# Draft Architectural Guidelines

## Community Feedback

Updated on March 18, 2023

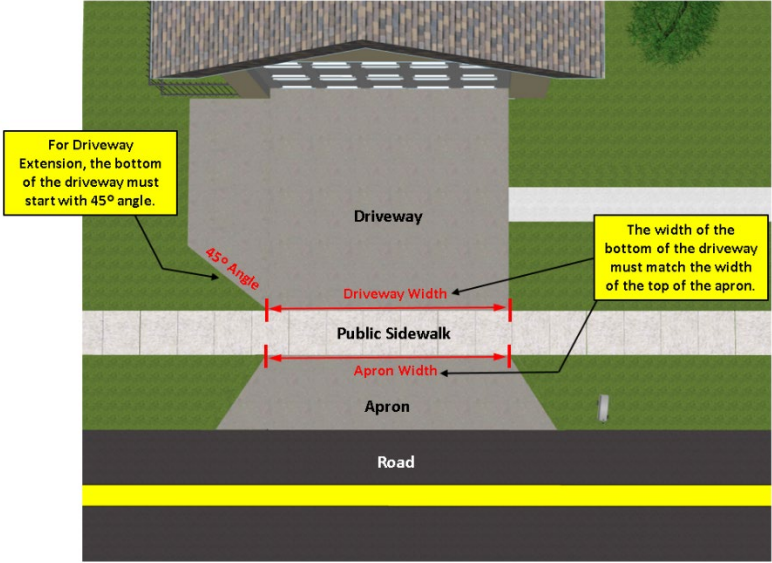
Page 54 – Color palette for “Modern” style homes. Only colors in the brown family are approved now?
